MEMORANDUM

Subject: Inspection of Fishways at Conowingo Hydroelectric Project (FERC #405) on May 5, 2014

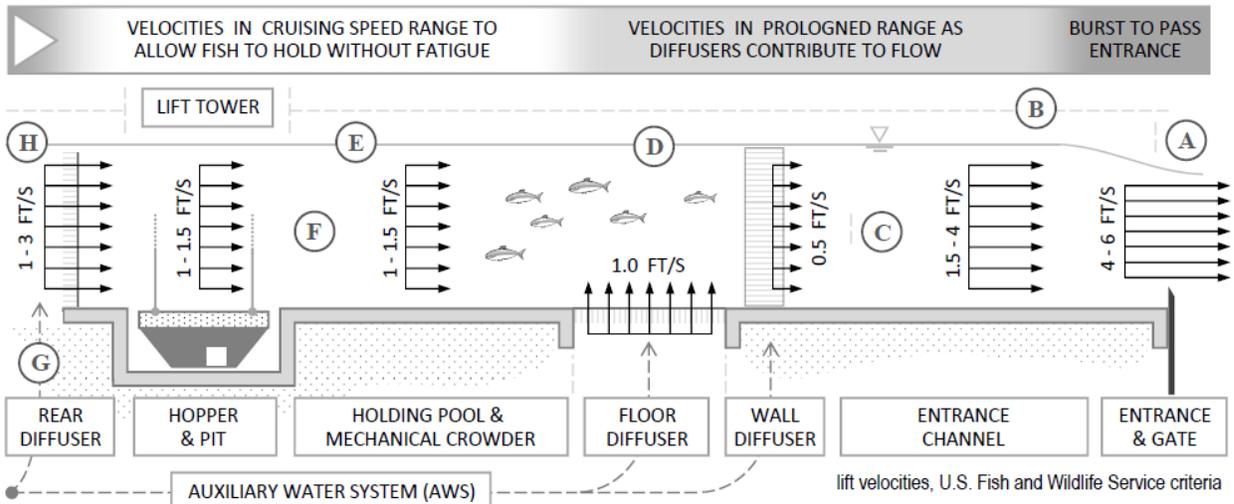
- Attraction flows - The EFL attraction water is fed through the western-most spillway bay. A significant fraction of this flow is passed down the ogee crest, through a stilling basin and into the entrance channel. The stilling basin is still not capable of dissipating enough energy to effectively allow the discharge of the original design flow (i.e., 900 cfs). The Service criterion for energy dissipation on attraction water systems (AWS) requires a volume of at least 16 cubic feet for every cfs. The aeration and turbulence observed have been shown to dissuade shad movement. Discussions with Exelon's operators suggest that the current entrance channel design

is incapable of passing more than 300 cfs without significant turbulence and aeration. Delays and ineffective passage due to insufficient attraction water are a concern.

- Water velocities - Velocities within the fishway do not seem to be meeting the Service criterion on fish lifts (see appendix for a reference sheet on appropriate fish lift water velocities). Even though velocity measurements were not taken during the inspection, water velocities in the entrance channels and the crowding area seem to be lower than desired. The Service recognizes that at 300cfs Exelon is providing 1/3 of the original design flow (i.e., 900 cfs) and causing the water to move slower than originally intended. The Service recommends that water velocities be physically measured to ensure that optimum conditions within the fishway are persistent during all operational flows.

- Hydraulic conditions – Large flow eddies (>1-foot) and other undesirable hydraulics could be observed inside the entrance channels. These adverse conditions can potentially impact the migratory cues and orientation of available fish, causing delays and/or fallbacks for those fish that have found the entrance but have yet to be crowded into the hopper.

- Water boil – A water boil was observed in the zone over the floor diffuser located immediately upstream of gate C. The Service criterion requires that point velocities emitting from the floor diffuser do not exceed 1.0 fps. Minimum water depth over the floor diffuser should allow the diffuser flow to make a 90° bend and change from vertical to horizontal orientation before reaching the water surface.

- Operation of entrance gates - The EFL currently does not operate with more than one entrance gate opened at a time. During the day of the inspection gate C (the most downstream gate out of all three available gates) was the only operating gate. Even though gates A and B were supposed to be completely closed, gate B was discharging enough weir flow to allow fallbacks from disoriented or unmotivated fish. During the inspection dozens of fish were observed exiting the fishway through gate B.

- Entrance conditions - During the day of the inspection operating gate C was set at an elevation that resulted in a head differential between the entrance channel and the tailwater larger than the recommended drop by the Service criterion (i.e., 4 to 6 inches). In the day of the inspection the fishway operator indicated that the drop could have been as high as 18 inches. A hydraulic drop larger than 6 inches could result in a velocity barrier for weaker swimmers like river herring. There was no easy way for the Service inspector to read the staff gage on the external side of the fishway. The Service recommends that the head differential between water surface inside the fishway and water surface in the tailrace be continuously collected and recorded.
